MINNEAPOLIS-HONEYWELL REG	Oved For Relea	as& \$60	14424R3 NGIAC			TRACTOR'S RECOMMENDED PRIORIT	
AERONAUTICAL DIVISION		PROPOSAL ADM-956 REV. 8/6			LEN	MERGENCY X UPGENT ROUTIN	
		FOR USE WITH ANA BULLETIN NO. 39					
1 ECP NO.	DATE	CONTRA	CT NO.		N PRODUCTION		
1		P.T.			YES NO		
2 NAME OF COMPLETE ARTICLE			J		SPEC, DWG. NO.		
Navigation Panel			CG8006	AL			
3 NAME OF PART OR LOWEST	SUBASSEMBLY AFFEC	TED				NO.& MODEL, OR TYPE NO. OF PA OWEST SUBASSEMBLY AFFECTED	
Switch Rotary						D907599-2	
4 NATURE OF CHANGE	- Coloot Crui	+ ab!!	Donlage fr	ant.	GFE AFFECTED		
Change "Destination panel to define new		J116	YES	NO X			
paner to define nev	/ IdiiCtions.	Dec 2.			DATE REQ. AT CO	ONTRACTOR'S PLANT	
5 REASON FOR CHANGE (INCL	UDE EXPLANATION (F ITEMS	CHECKED IN NO.	BELOW OR	CHANGE (CHECK	ONE)	
Increase capability of selecting destinations from 8 to							
16 locations. See Attachment					INITIATED BY CONTRACTOR FOR

ENGINEERING CHANGE PROPOSAL

E.C.P. NO. 1

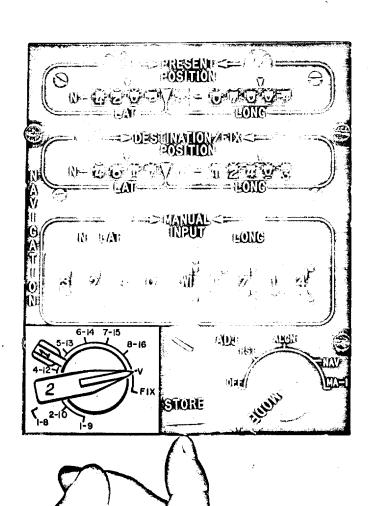
This modification will require the replacement of the present destination select rotary switch on the Nav Panel with a concentric shaft rotary switch. This switch will contain an inner shaft with four decks and ten positions (switch #2) as is currently used, and the outer shaft with a single deck and two positions (switch #1). Switch #1 is a lever type switch.

In operation switch #2 will transmit four lines of binary information which will be decoded by the computer for the purpose of selecting one of eight possible destinations. Prior to this selection, the computer program will look at the output of switch #1. This is in the form of a discrete to the computer. If the contacts of switch #1 are open, the decoded output of switch #2 will be recognized as destinations 1 through 8. If the contacts of switch #2 are closed, the computer will recognize the output as destinations 9 through 16.

The present face plate will require a replacement with one containing the engraving necessary to display the additional destinations. In addition, a minor redesign of the panel lighting technique will be required.

Performance - Changes due to an added function being incorporated into the Nav Panel.

Operating Procedure - Changes since a second switch now commands the original switch. The operator must be aware of his actions with regard to the two switches.

Spare Parts Exhibit - The type switch is being changed and the face plate will also be replaced.
